ENCLOSURE 3

Markup of DCD Revision 18, Section Appendix 3G

AP1000 Design Control Document

Figure 3G.2-16

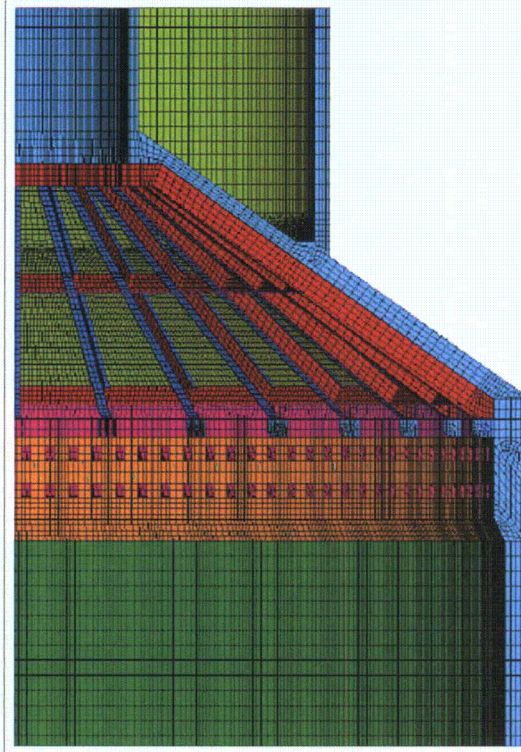
Comment [rmk32]: 12

X Direction FRS for Node ~~8573~~ (NI10) or 3329 (NI20)
 ASB Shield Building Roof Elevation 327.41'*

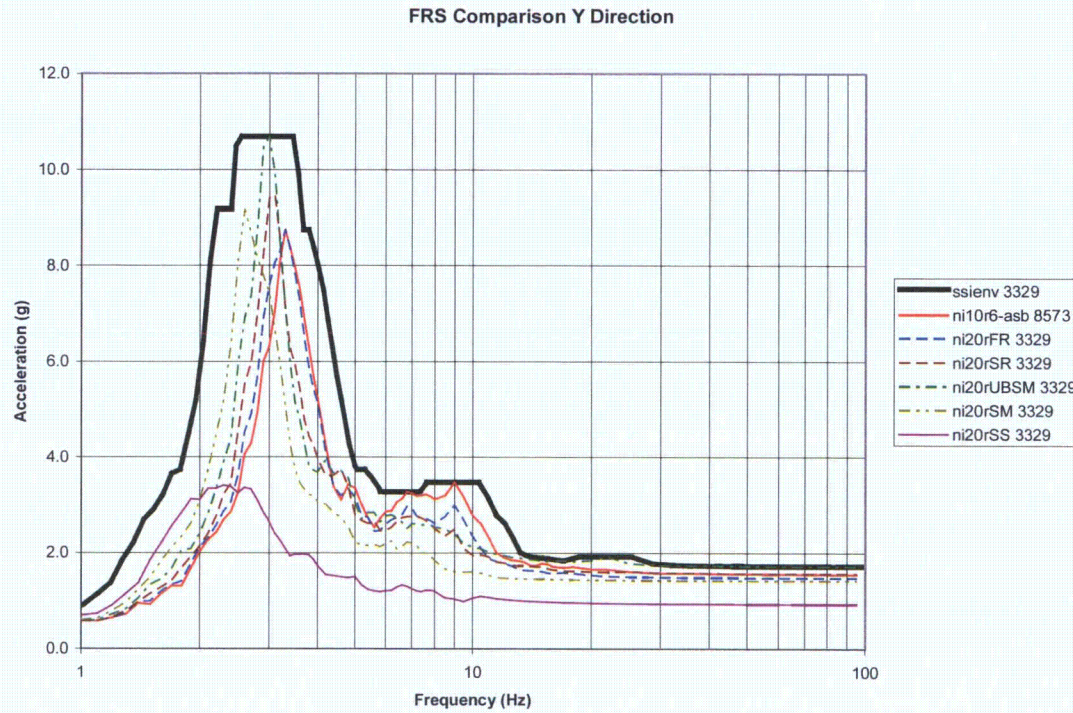
Comment [tlw36]: 37
 Deleted: 2862

Y Direction FRS for Node **8573** (NI10) or 3329 (NI20)
 ASB Shield Building Roof Elevation 327.41']*

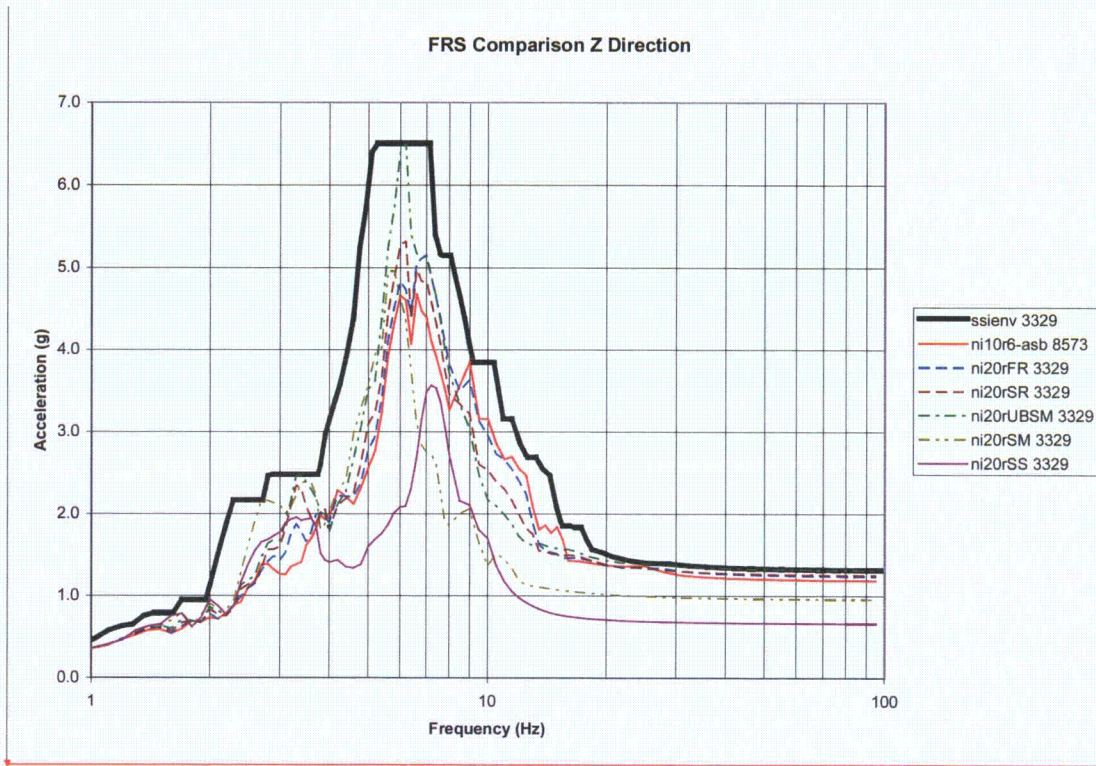
Comment [tw37]: 37

Deleted: 2862

Z Direction FRS for Node **8573** (NI10) or 3329 (NI20)
 ASB Shield Building Roof Elevation 327.41']*

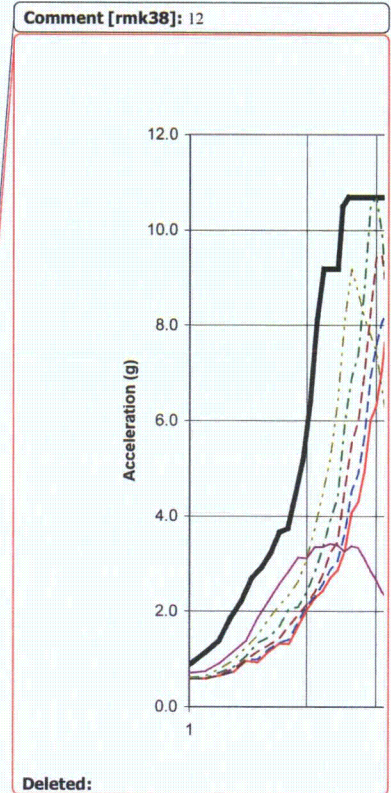
Comment [tlw39]: 37
 Deleted: 2862

Figure 3H.5-11 (Sheet 6 of 6)

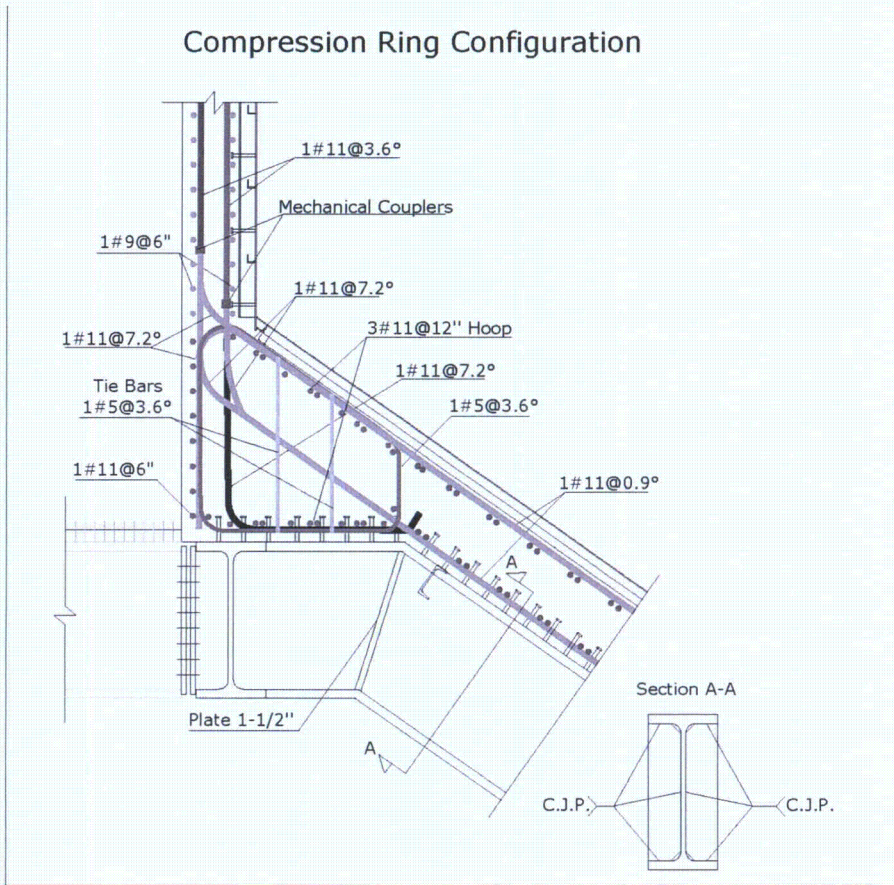
Comment [tlw160]: 37
